AMENDMENT.

proposed first floor extension
FIELDSIDE COTTAGE, BROOKSIDE, BUXWORTH.
(formerly ROSE COTTAGE).

* amended 25/04/08. a. Juliet window in gable wall.

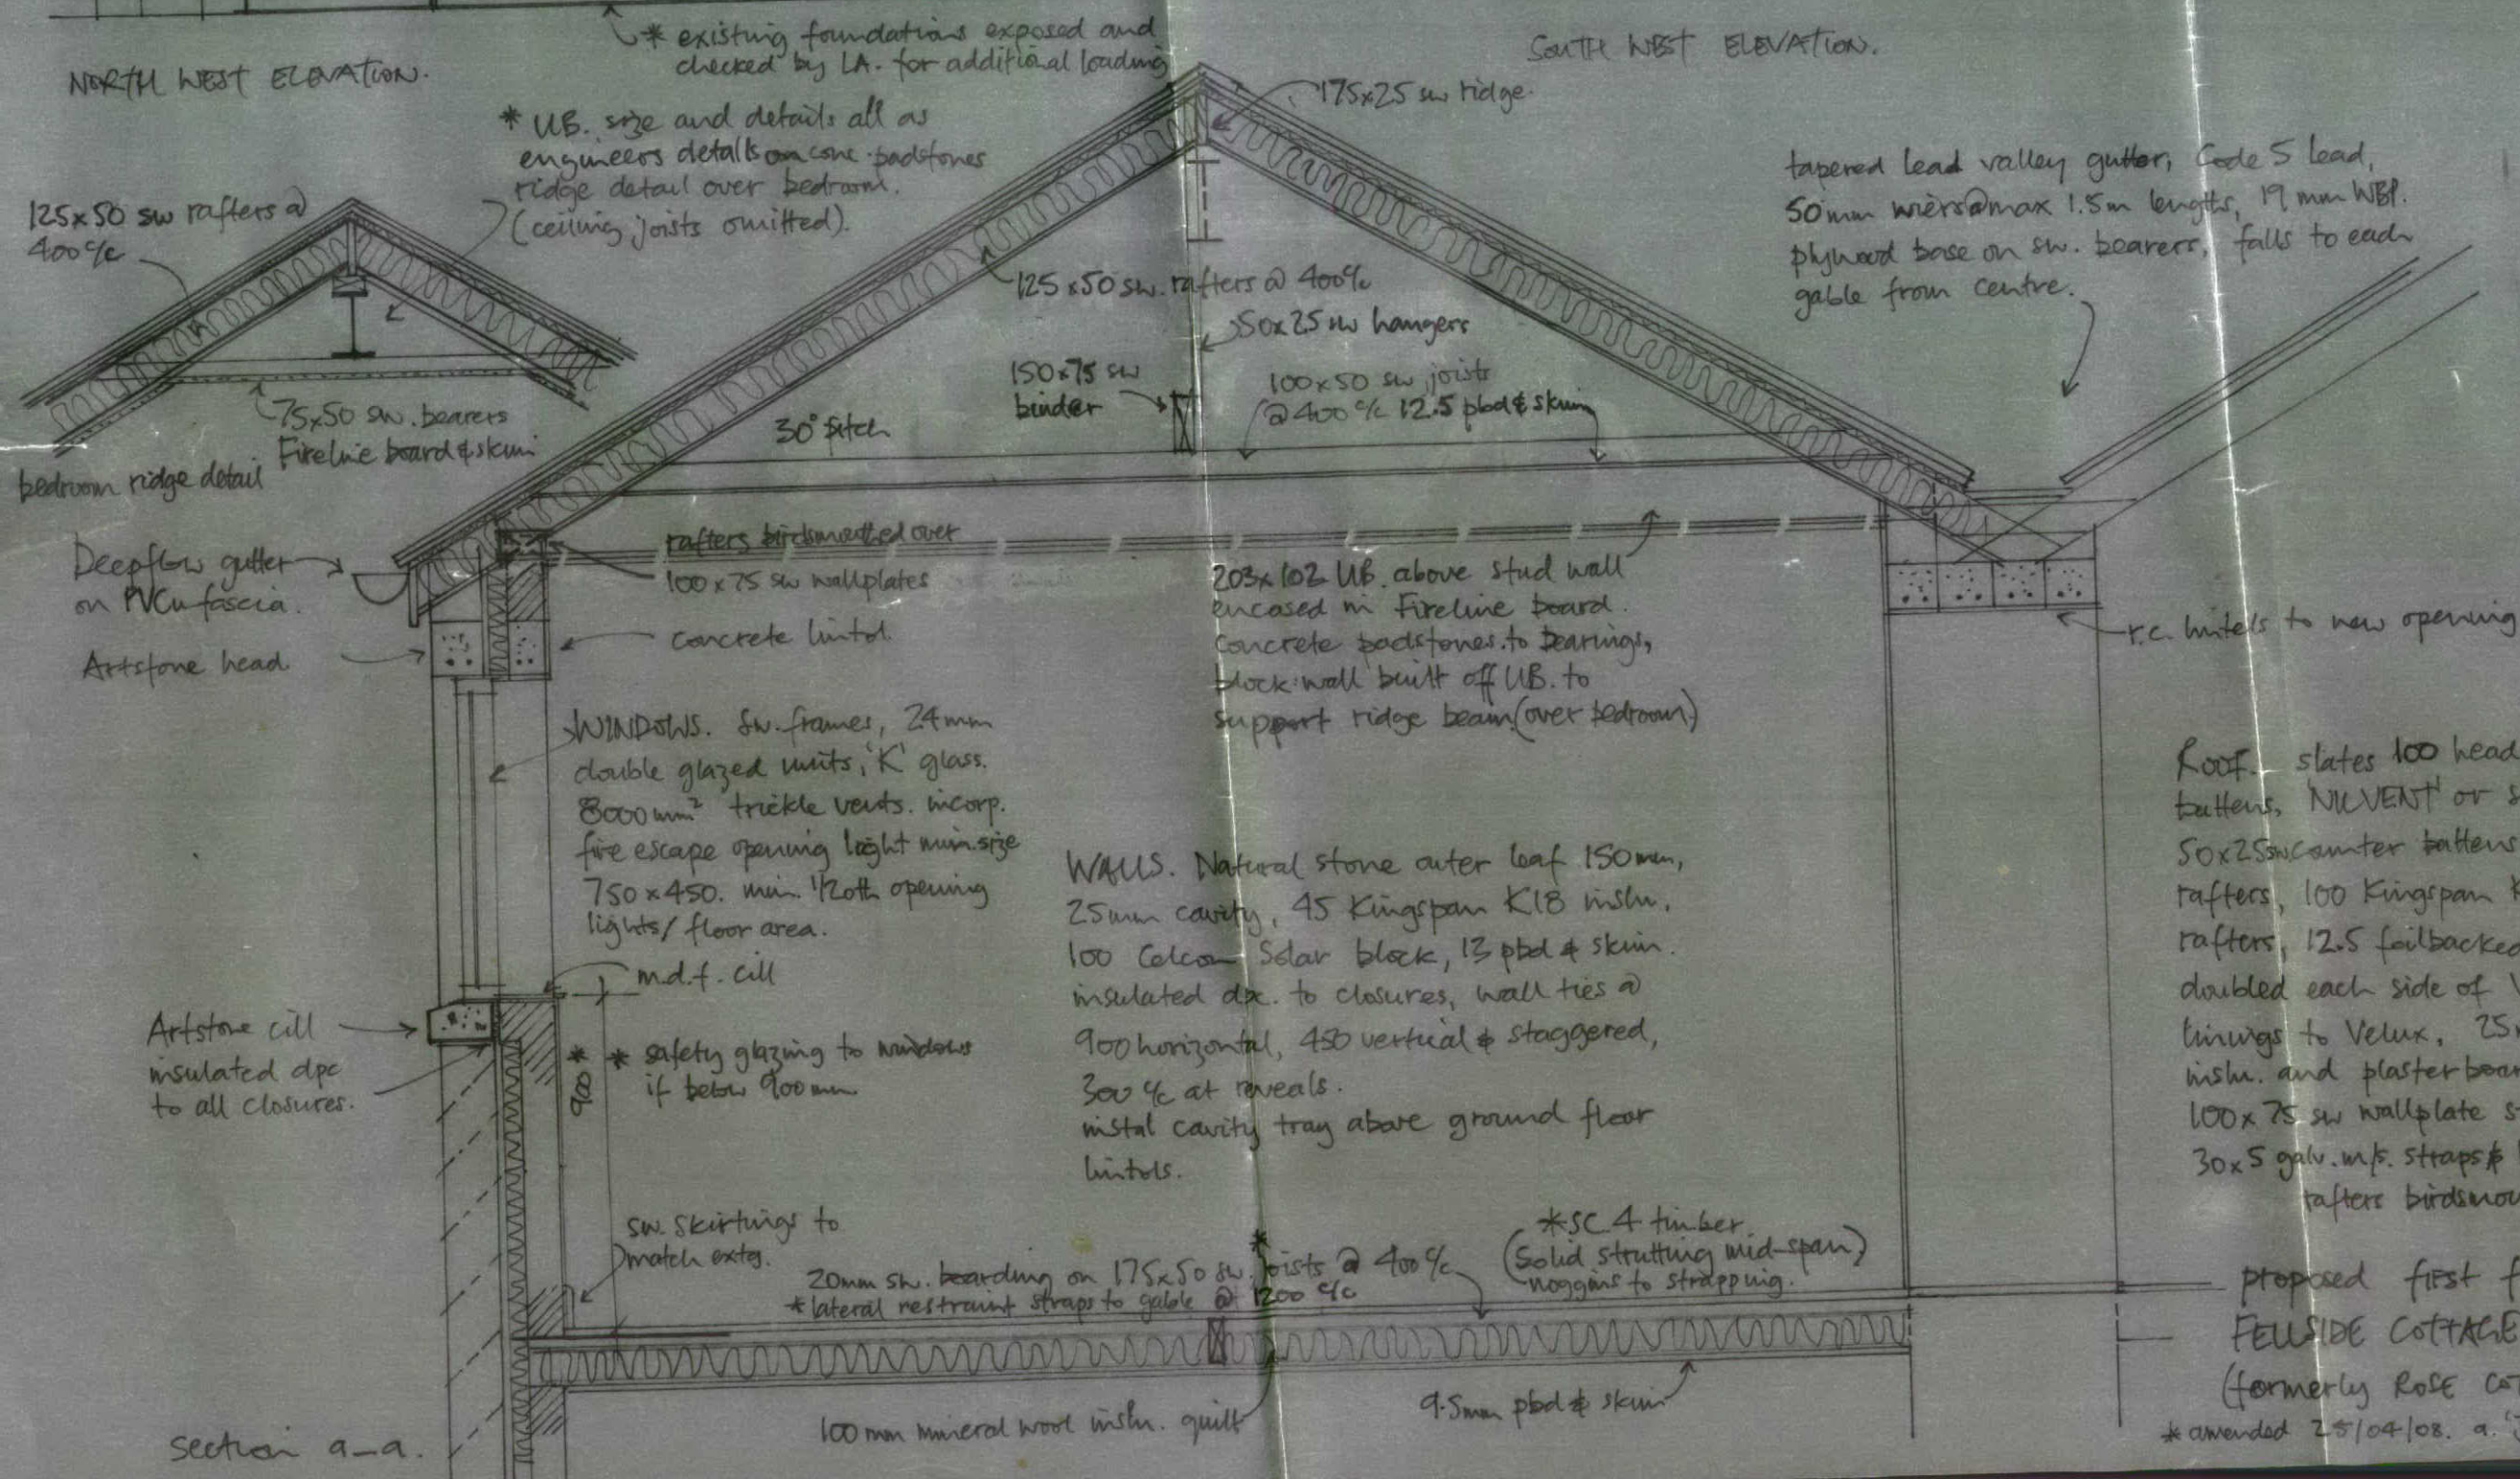
* Juliet window with metal guarding to comply with Part K Bldg. regs.
